Product Change Notice (PCN)

PCN Number: PCN-045-1167R-01

Product(s) Affected: PJ-042H

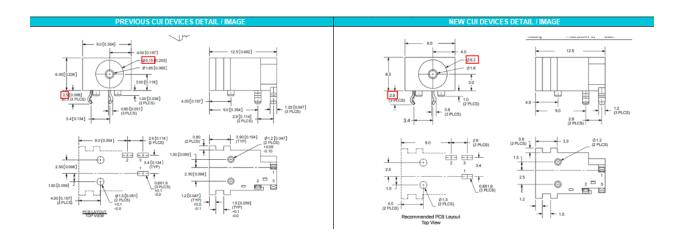
Reason(s) for Change: Manufacturing Improvement process. Tooling Upgrade

Description of Change: Minor Structural and material Difference. See image Below

MATERIAL	PLATING
center pin	brass	tin
terminal 1	brass	tin
terminal 2	copper alloy	tin
terminal 3	brass	tin
nlastic	PAGG

DESCRIPTION	MATERIAL	PLATING/COLOR
center pin	brass	tin
terminal 1	brass	tin
terminal 2	phosphor bronze t=0.3	tin
terminal 3	brass t=0.3	tin
housing	PA66 (UL94V-0)	black
